Dunsbury Hill Farm
Transport Assessment Addendum
Portsmouth City Council

15th January 2013

This report has been prepared in response to comments received from Hampshire County Council (HCC) and the Highways Agency (HA) requesting additional information. Initial responses to the comments are presented in Appendix A.

Subject: Highways and Transportation –
Comments from HCC and the
HA and Atkins response

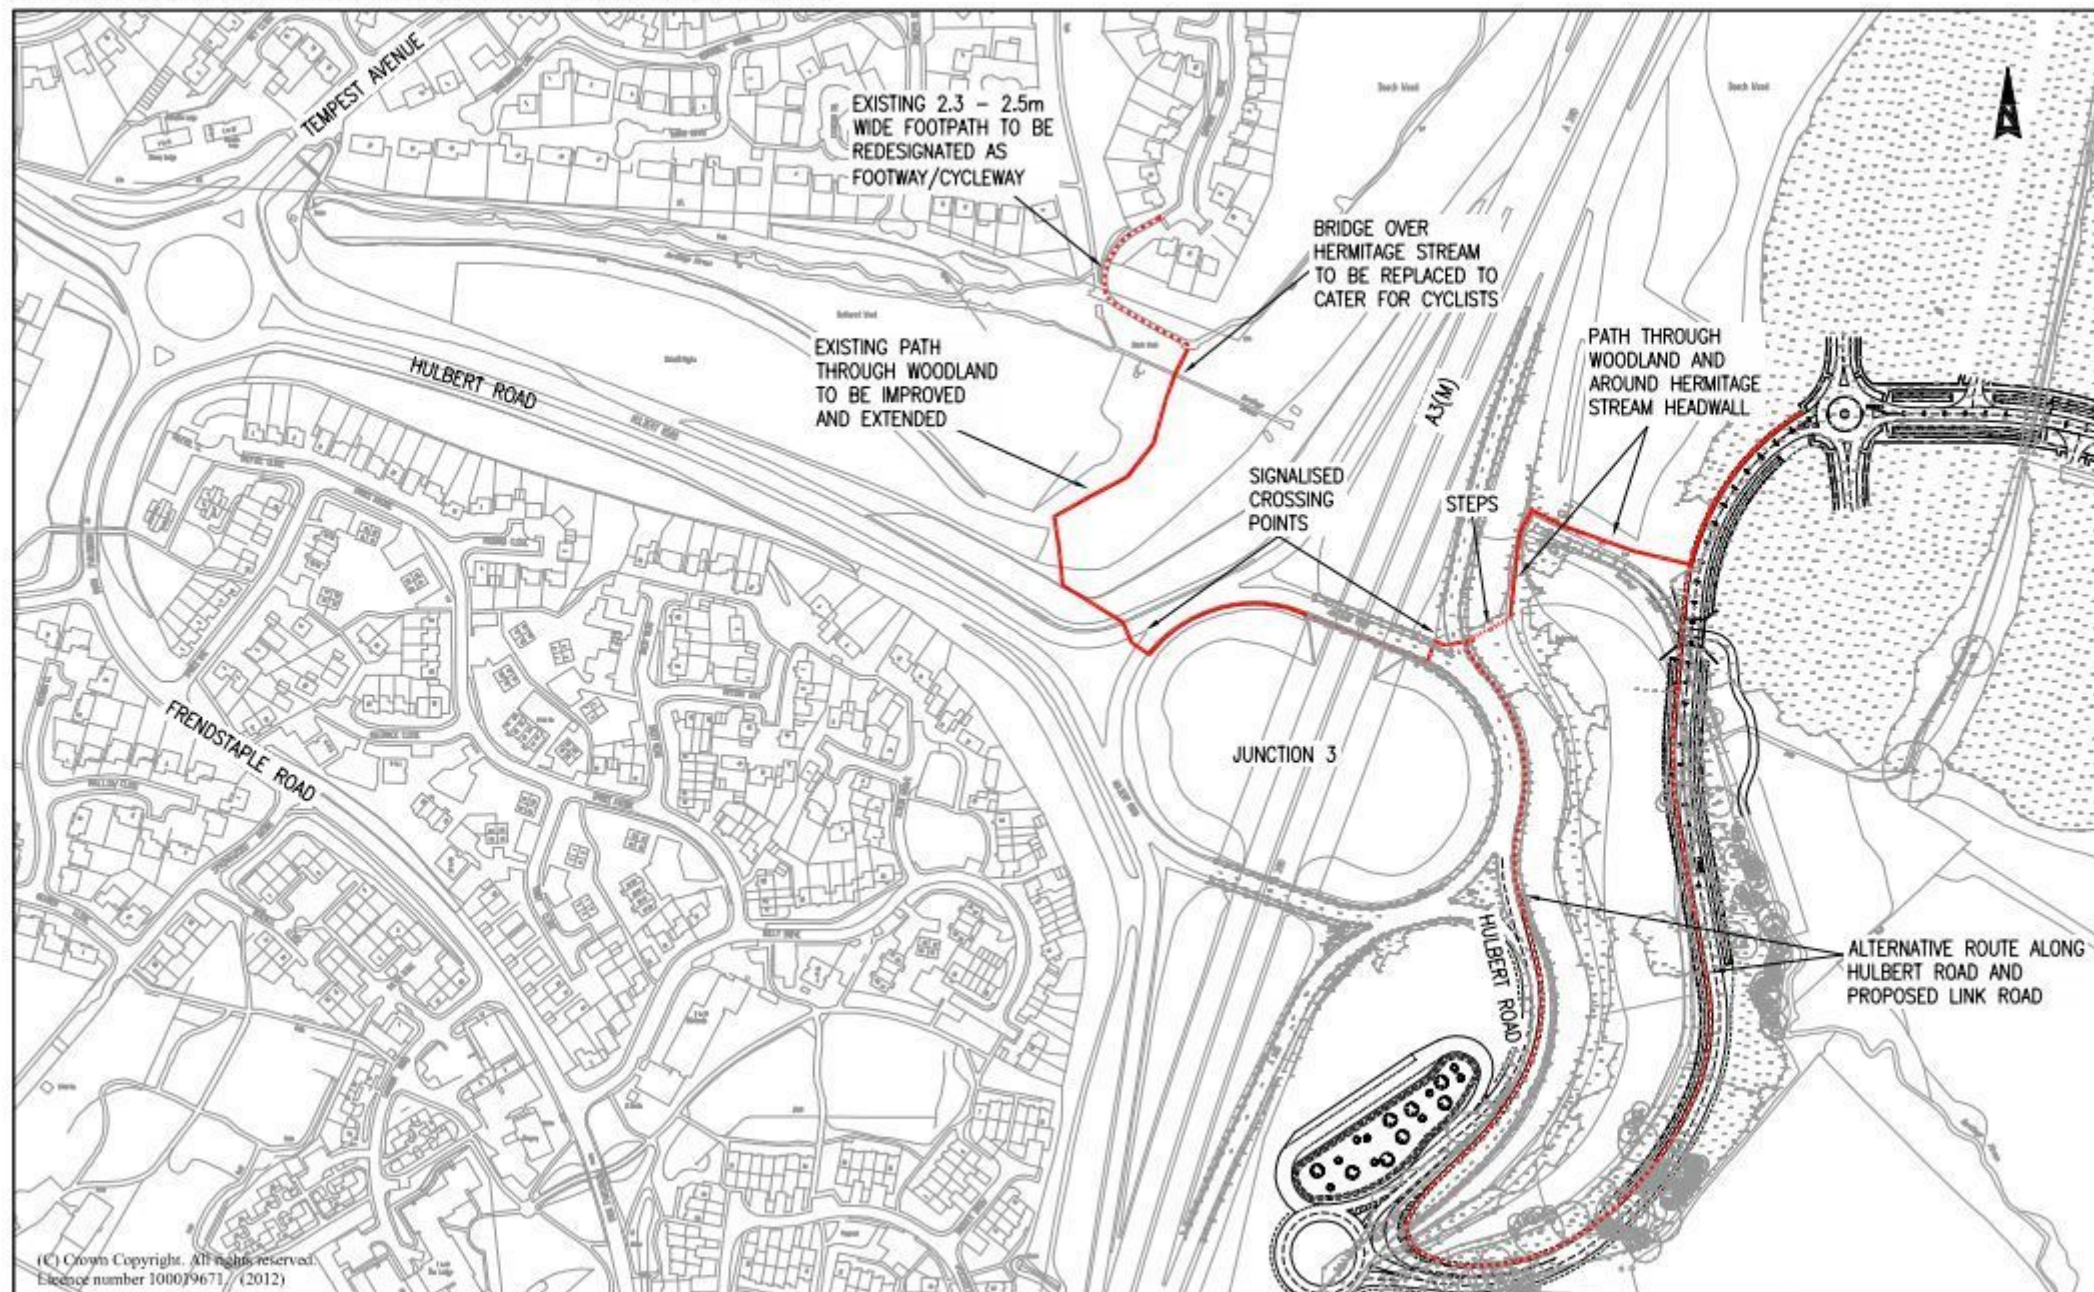
cost issues balanced against the expected demand from the DHF development, HBC have requested that a reduced scale scheme, linking the site to the existing Outhurst Wood / Beech Wood footpaths, is considered.

Figure 1 shows the revised potential route, including a link to the existing Outhurst Wood / Beech Wood track from the A3(M) Junction 3 junction.

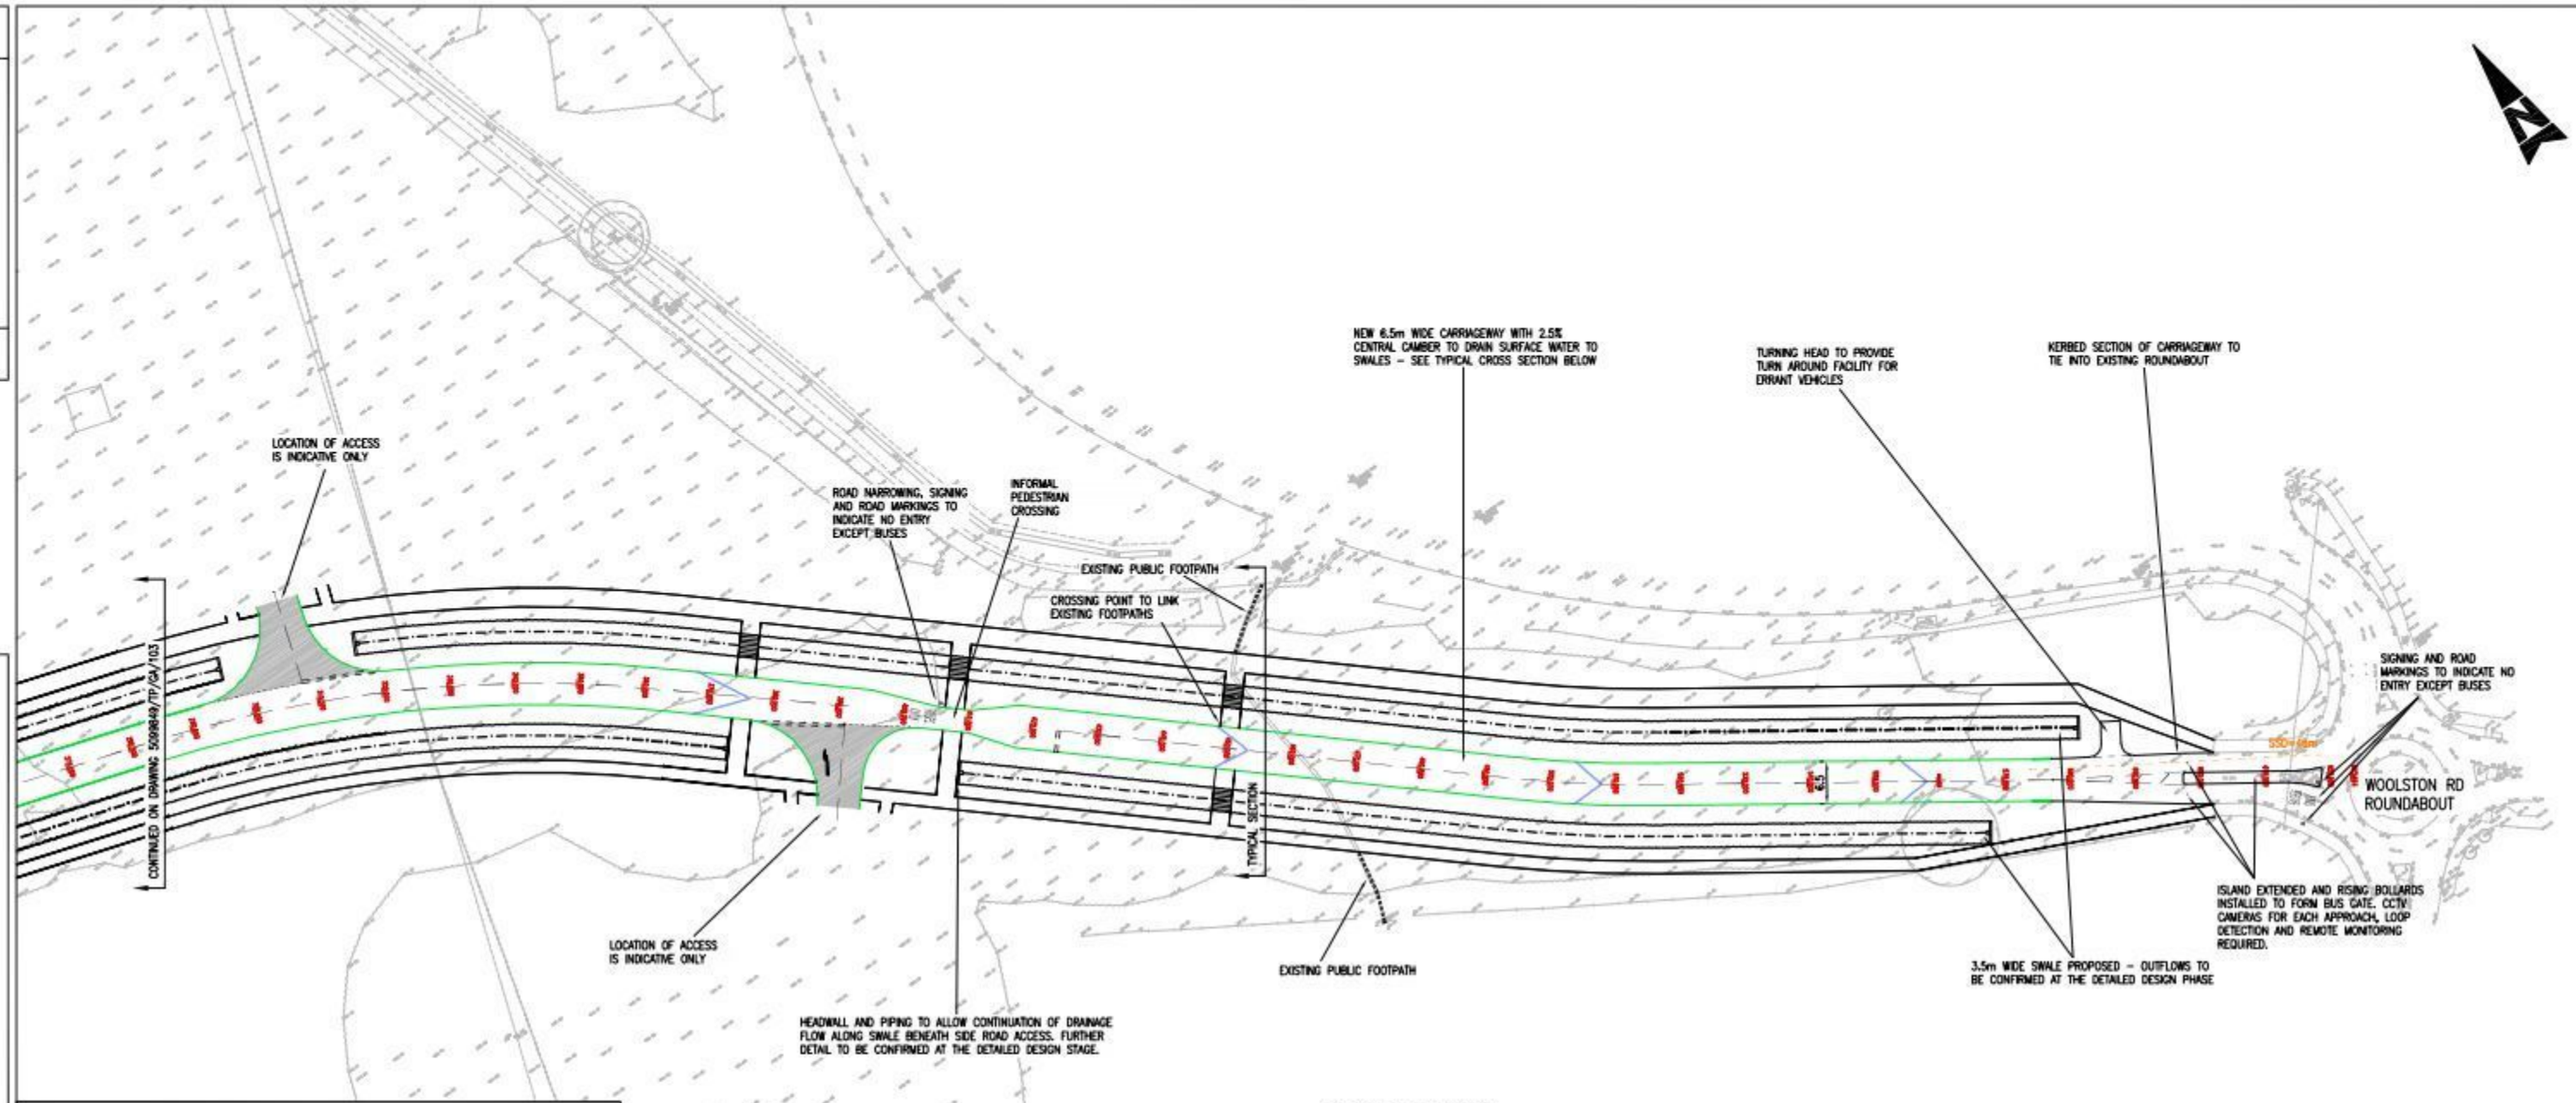
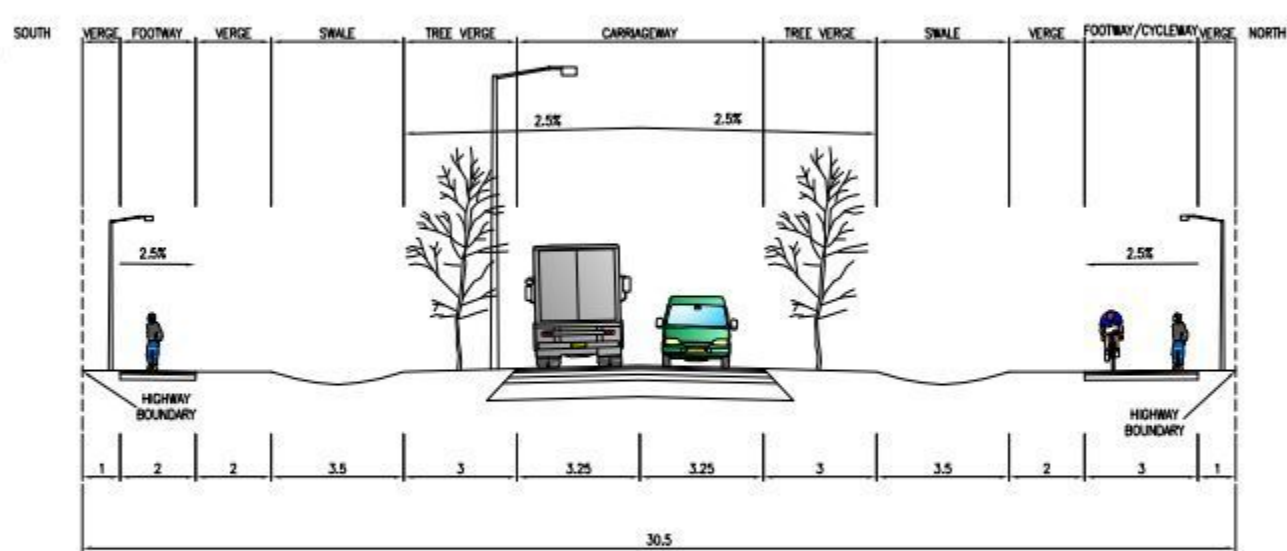
HCC SJ 08/12: **"Drawing 104.** The location of the CCTV cameras should be shown, it is suggested that these be placed on the nearside verges facing oncoming vehicles. An area of hard standing will be required for maintenance vehicles for the bus gate. Preferred location would be to the west of the bus gate. Appropriate signage and road marking should be considered to highlight the bus gate, with the possibility of red coloured surfacing."

HCC SJ 08/12: **"Drawing 104.** The rising bollards that enable the bus gate to be provided should be located a minimum of 25m from the roundabout 'Give Way' to allow for a bus to exit / enter the roundabout without encroaching on the bollard or the roundabout. Due to this the central island will need to be extended 5m beyond the bollard, thus the central island should be a minimum of 30m in length. Furthermore consideration should be given to preventing vehicles from mounting the footway and bypassing the bollard."

HCC SJ 08/12: **"Drawing 104.** The bus gate is situated approximately 200m from the nearest turning point on the western side, therefore any vehicle passing this turning will not be able to turn around when confronted by the bollard thus needing to reverse a considerable distance. Therefore it is necessary for a turning head to be provided for an appropriately sized vehicle. Consideration should be given to amending the geometry of the last access road to the west of the bus gate, this should be changed to effectively make the bus link the side road. This could be achieved through a combination of measures such as road

HCC SJ 08/12: **"Drawing 104. Vertical Alignment:** The applicant will need to consider the driveability of the vertical alignment on the southern approach to Hulbert Roundabout due to the undulating characteristic of the alignment and consider the eastern approach to the Hulbert Roundabout due to the steep incline. Some vehicles will need to stop on this incline and undertake a hill start which may not be ideal for some drivers. Therefore the applicant shall consider reducing the incline where possible as part of the Section 278 process."

HCC SJ 08/12: **"Drawing 104.** Drainage Proposals: the applicant shall provide all correspondence with the Environment Agency regarding the diversion works to Hermitage Stream, including flood risk analysis, all discharge consents that are required and the water quality report within a future submission."

HCC SJ 08/12: **"Drawing 104.** Street Lighting Proposals: Maintenance numbers of all existing street lighting furniture, including illuminated signs and bollards shall be provided at the detail Section 278 stage."

P FOR HCC APPROVAL	10.12.12	SS	C	BUS GATE AMENDED, ROAD NARROWING AND TURNING HEAD ADDED	SD	10.12.12	ND	SS			
P FOR HCC APPROVAL	29.2.12	JA	B	FOOTWAY ADDED AND CROSS SECTION AMENDED	SD	29.2.12	ND	JA			
P FOR HCC APPROVAL	04.11.11	IPC	A	ORIGINAL ISSUE	MBW	04.11.11	SD	IPC			
Stat Purpose of Issue				Date	Auth	Rev	Description	By	Date	Chk'd	Auth
